ENVIRONMENTAL PROTECTION AGENCY

40 CFR PART 52

Final Response to Petition From New Jersey Regarding SO₂ Emissions From the Portland Generating Station

ACTION: Final rule.

Figure VI.C-1. Comparison of 2010 Emissions from Portland Units 1 and 2 with Allowable Emissions and Different Levels of Reduction from Allowable Emissions.

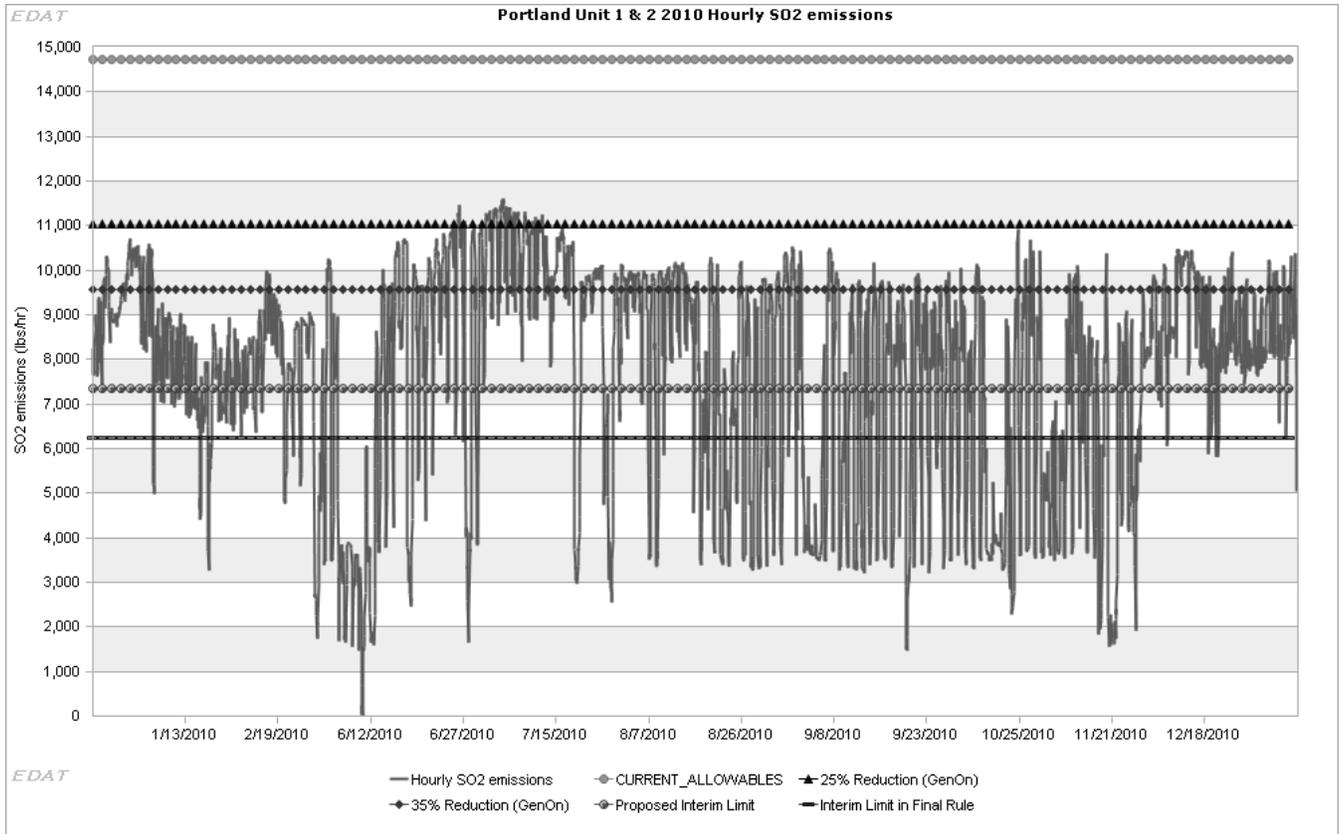
Comment: Based on the results of the test burn report, GenOn concluded that (1) sustained unit operations using a blend of Northern and Central Appalachia coals sufficient to achieve a 25 percent reduction in allowable SO₂ emissions is achievable with a modest investment and an implementation schedule of 6 months, and (2) sustained unit operations using a blend of Northern and Central Appalachia coals to achieve a 35 percent reduction in allowable SO₂ emissions should be achievable with additional investments and an implementation schedule of 8 to 12 months after GenOn has established an operational record and completed equipment performance evaluations at the 25 percent reduction blend level, and any necessary permits are acquired.

Response: The EPA evaluated the suggested interim reductions in the GenOn test burn report. The EPA concluded that based upon this evaluation, these targets are significant underestimates of the readily available interim emissions reductions, represent very minimal reductions from current operations, and are inconsistent with the results of the test burn.

Figure VI.C-1 shows the hourly SO₂ emissions for all of 2010 at Portland, shown as the sum of emissions from units 1 and 2. For the EPA (and GenOn's) air quality analysis, the assumed allowable emissions rates for units 1 and 2 were 5820 lb/hr and 8900 lb/hr, respectively, resulting in a total allowable rate of 14,720 lb/hour. A 25 percent reduction from this amount, that is a 25 percent reduction from current allowable, thus becomes 11,040 lb/hr. As shown in Figure VI.C-1, during 2010, Portland's hourly emissions exceeded 75 percent of allowable emissions only rarely. Accordingly, a 25 percent reduction in allowable emissions effectively represents status quo operations. A 35 percent reduction in allowable emissions, or 9,568 lb/hr, would require at most a roughly 15 percent reduction in current emissions. EPA continues to believe that the facility can make much more significant reductions in line with the final interim limits within a year.
